## Swept Path Analysis Response

Job Title  
**NESTLE SITE  
HAYES**

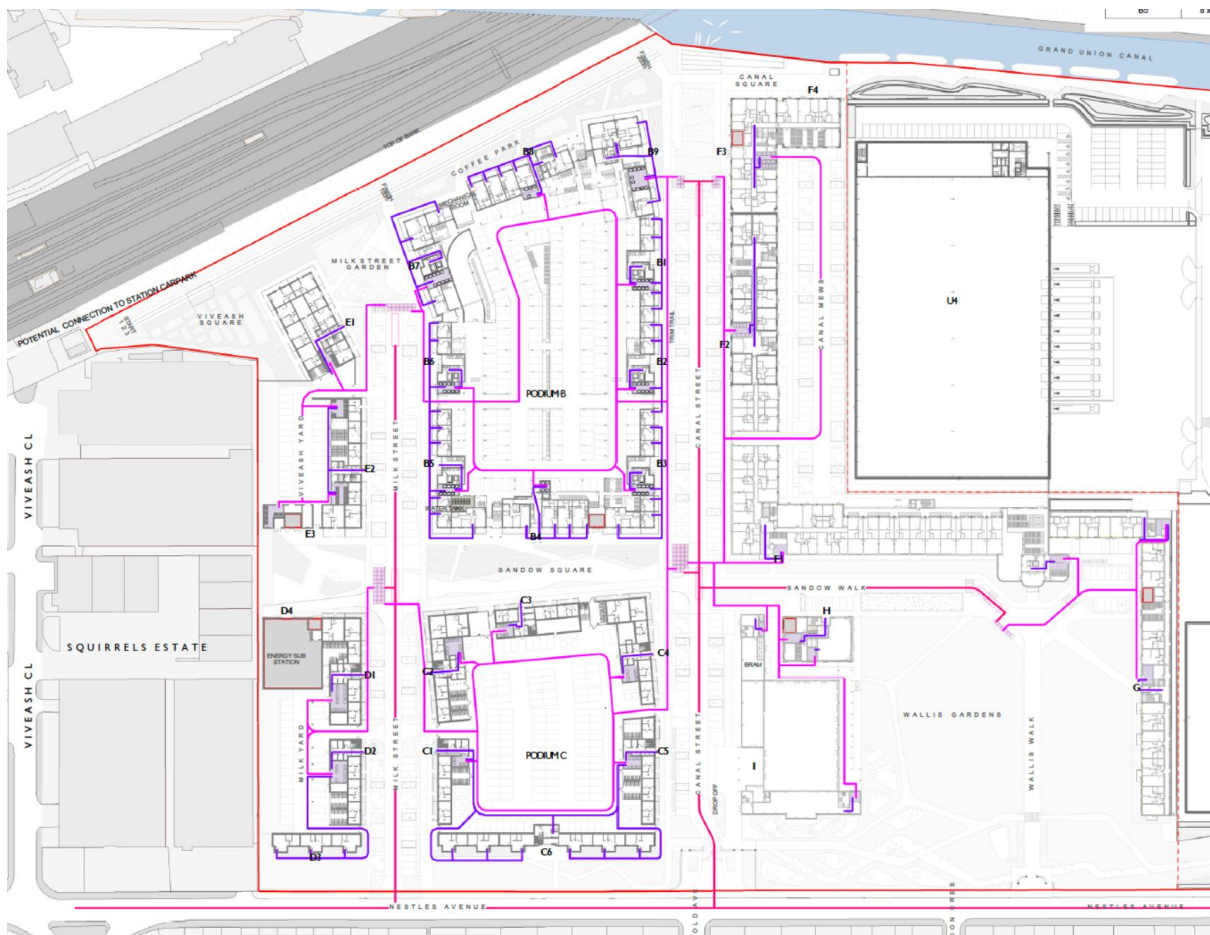
We understand the bins will be moved from stores to collection areas. The collection areas are not specified. These need to be identified on plans to ensure the collection vehicle can access them.

*The refuse collection locations are shown within the Waste Report that is incorporated into the Design and Access Statement. The relevant section of the DAS is attached. An extract of the plan showing the locations where the bins will be held on the morning of collection is shown below. It should be noted that in light of the refuse vehicle tracking at the northern end of Canal Street it is proposed to provide additional space to the south of Block B to accommodate the bins that would have been located in this area.*

Drawing Title  
**SWEPT PATH ANALYSIS  
FIRE APPLIANCE**

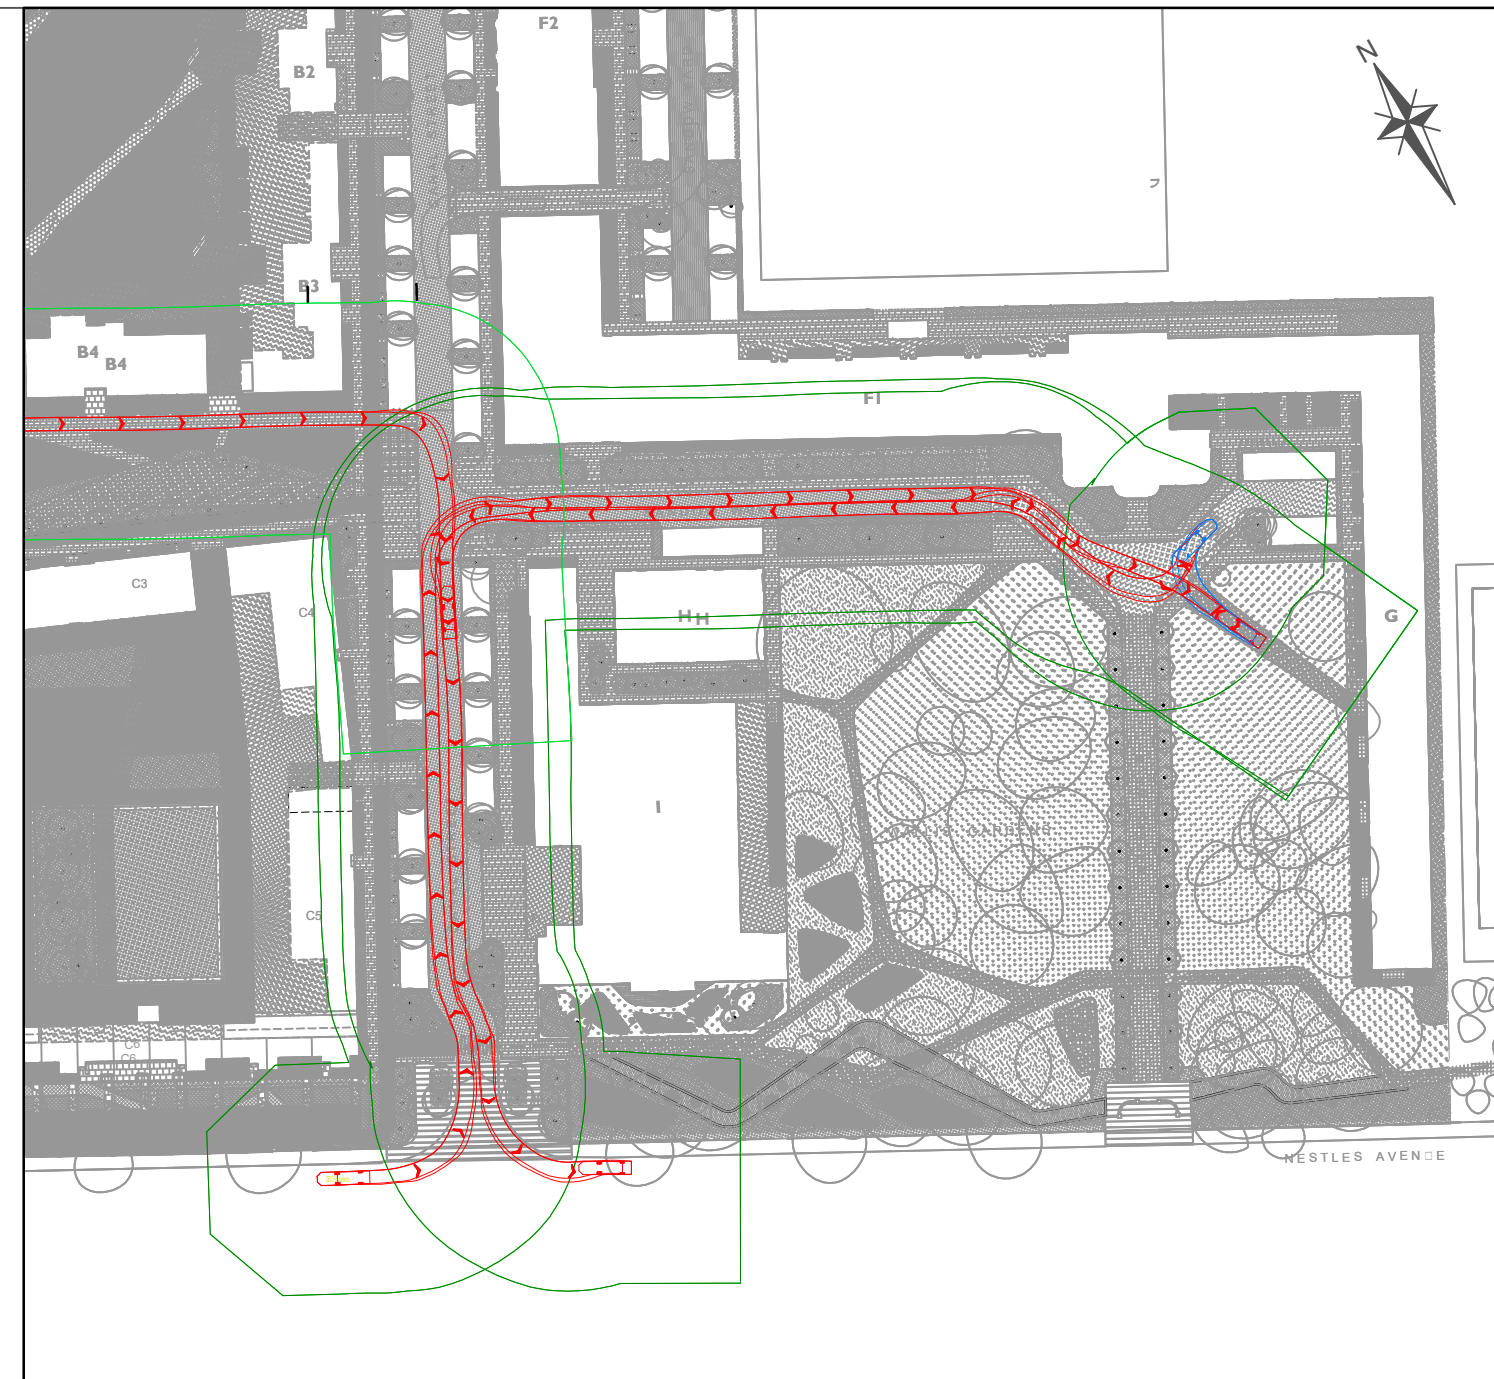
We would need further evidence of a fire tender being able to reach within 18m of all cores and dry risers. It would appear that this isn't possible for Blocks G, I, C6, D3, E1 and F4.

*We have worked closely with the fire engineer on the project to ensure that all dry risers can be accessed within 18m of a fire tender. To demonstrate this, in Dwg 16018-01-010 Rev D, we have shown a 18m zone around the fire tender tracking around the site. It can be seen that all dry risers are accessible. For Block G, to avoid tree loss and major impact on the amenity value of Wallis Gardens, the dry riser has been located approximately 18m from the building.*

Drawing Title  
**SWEPT PATH ANALYSIS OF SANDOW ROAD  
 LARGE CAR**

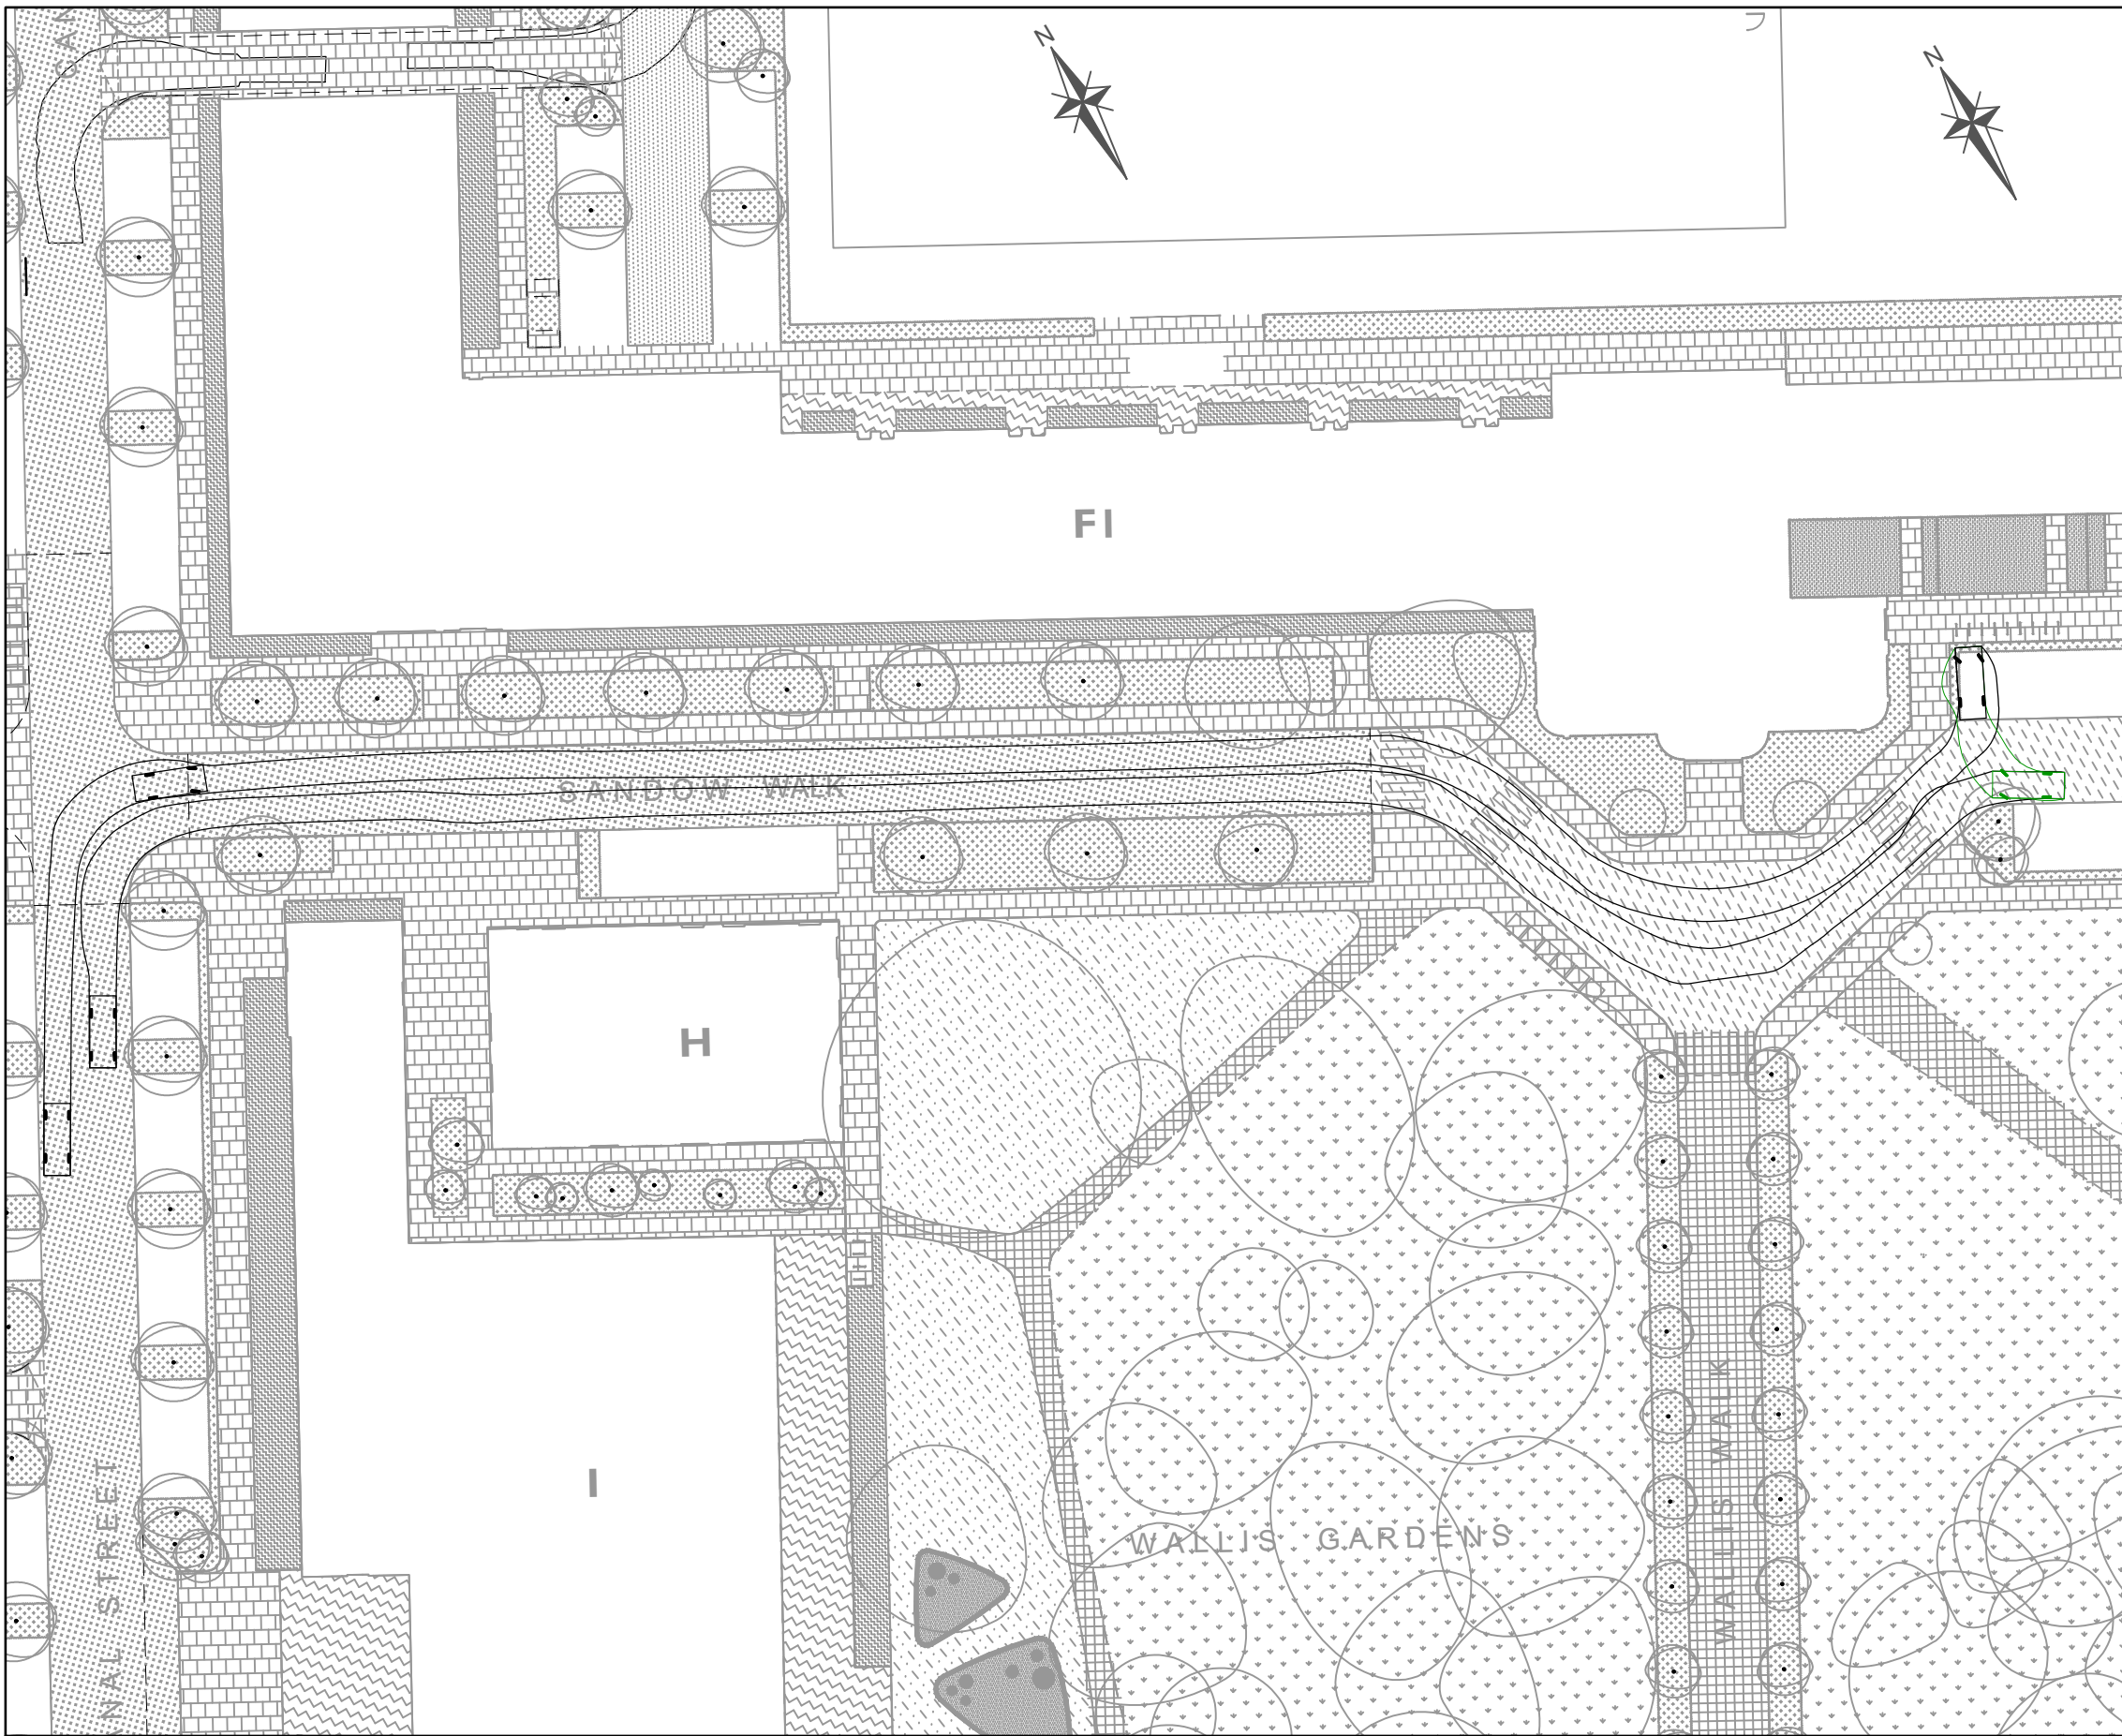
There is no vehicle tracking for cars with trailers along Sandow Yard / Canal Mews, Milk Walk, Viveash Walk, Wallis Walk (by Block G) or Milk Street. All these streets have car parking spaces, so inevitably they will be regularly used by cars. It's important to see the vehicle tracking for these parts of the site too.

*Sandow Walk has 6m carriageways in front of the 10 spaces at its eastern end and the 7 spaces outside Block H. As the number of spaces accessed from Sandow Walk is small and the number of vehicle movements will be minimal, the carriageway width has been reduced on other parts of the route. Car tracking is provided in Dwg No 16018-01-018 to demonstrate that this operates acceptably.*
